Addendum report

Modification of a determined review of environmental factors in Nightcap National Park, Mount Jerusalem National Park and Whian Whian State Conservation Area

Addendum Report: Modification of a Determined Review of Environmental Factors in Nightcap National Park, Mount Jerusalem National Park and Whian Whian State Conservation Area

Map 1 – Modifications (north)

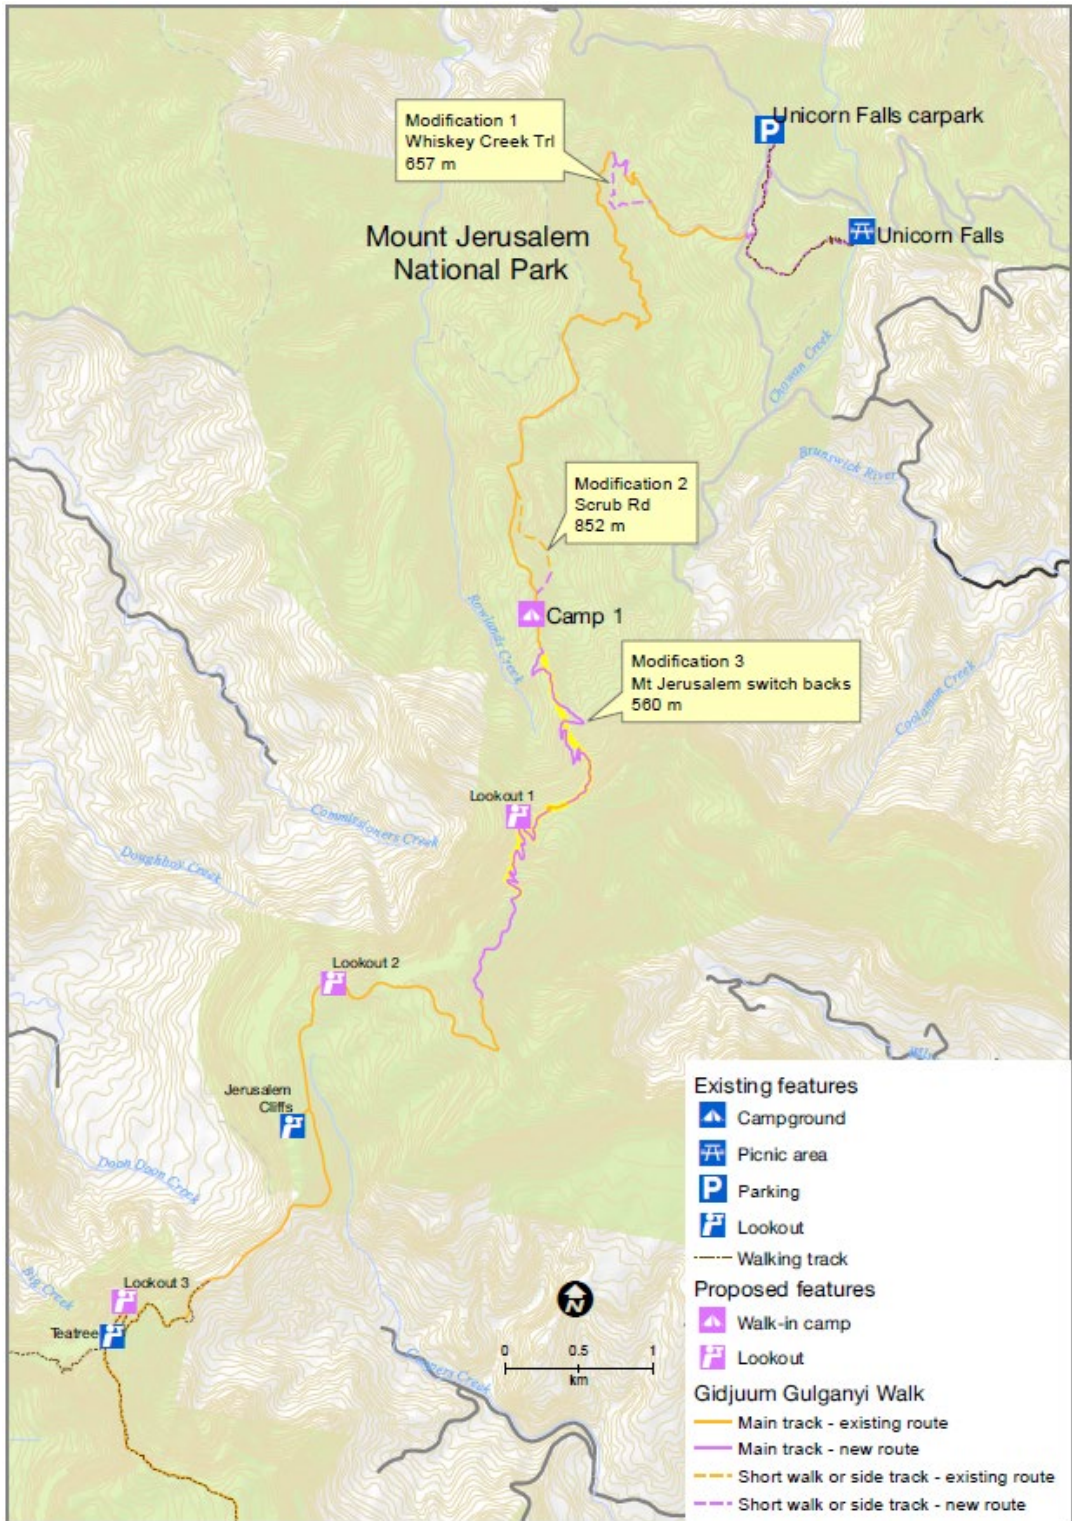
1. an additional short loop of approximately 800 m off the Whiskey Creek Trail section of the Gidjuum Gulganyi Walk that takes walkers down to a rainforest-lined creek before looping back onto the main walk. This sidetrack mostly follows an overgrown former logging road. The loop will be the terminal part of a half-day walk starting and finishing at the Unicorn Falls car park (see Map 1). Note that the proposal in the draft master plan to include a side-track to Rowlands Creek (see above) has been replaced by this proposal

2. an additional side-track of approximately 700 m along the largely overgrown Scrub Trail that runs parallel to Hells Hole Creek. The track then winds its way up to Sand Ridge Road near Camp 1 via a series of switchbacks/steps (see Map 1)

3. a realignment of the ascent up Mt Jerusalem to reduce the number of steps required by adding in a series of switchbacks. The proposed new alignment varies by up to 250 m off the former alignment and adds 560 m to the ascent (see Map 1)

Map 2 – Modifications (south)

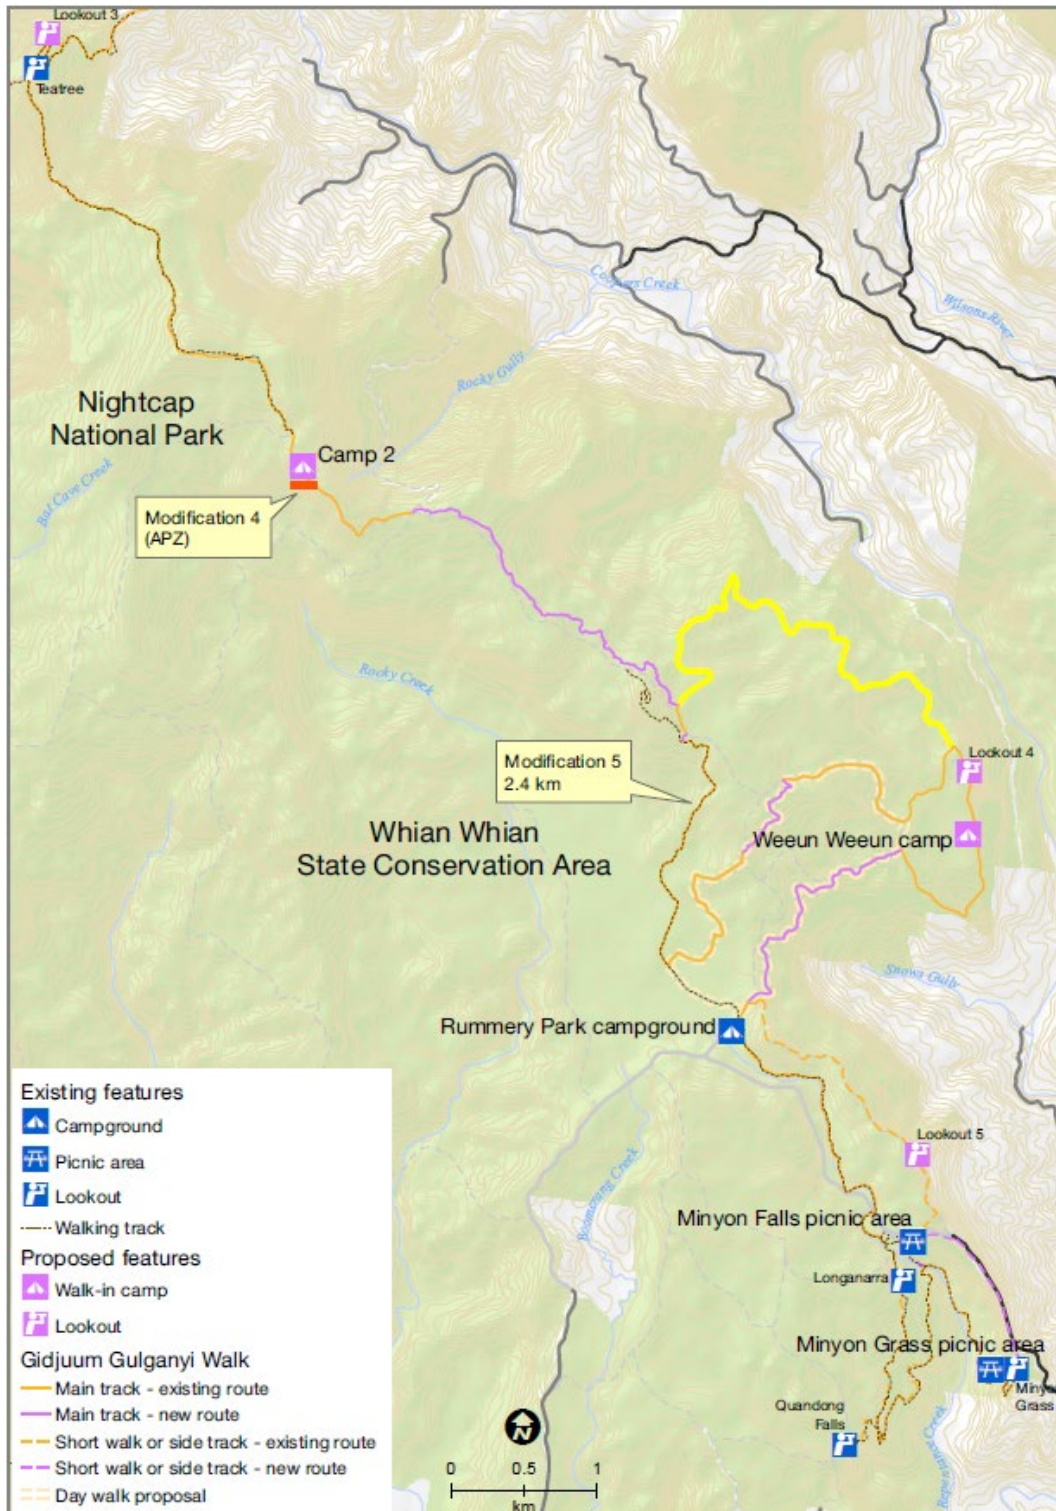
4. the inclusion of an APZ at Camp 2 in Nightcap National Park. This will require modification of vegetation immediately south of the camp to reduce fuel loads (see Map 2)

5. a realignment of Day 3 to avoid the use of Eastern Fire Break as part of the walk. Instead, the alignment now joins Peates Mountain Track south of Peates Mountain. It then follows a series of former logging roads (now largely overgrown) before crossing Peates Mountain Road and linking up to Perlite Road before reaching the Eastern Fire Break. Parts of Day 3 will also be promoted as a half-day loop walk from either Rummery Park or Minyon Falls (see Map 2).
